North Carolina 2020 NEC Amendments

(Effective Date October 1, 2021)

Synopsis of Significant Changes Applying the 2020 North Carolina State Electrical Code

AMENDMENT 410.2

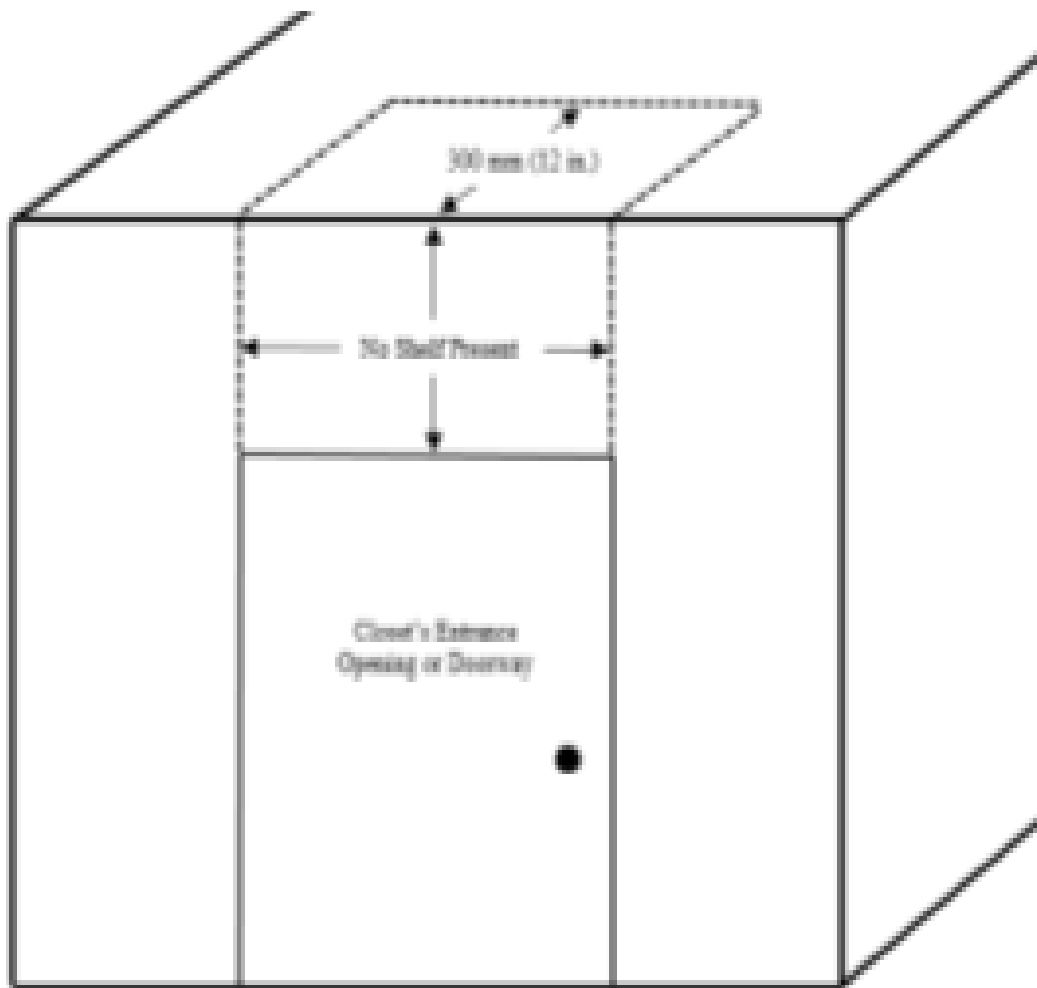
Adding Exception to definition of Closet Storage Space in section 410.2 for clarification with NC Building Designs; (moving the intent of a current amendment over to the new Code)

Exception: Where a shelf is not present in the area of wall above the closet's entrance opening or doorway extending from the top of such opening or doorway vertically to the ceiling, including the area of ceiling extending perpendicular from the area of wall directly above the closet's entrance opening or doorway to a horizontal distance of 300 mm (12 in.), shall not be defined as closet storage space. See Figure 410.2 Exception.
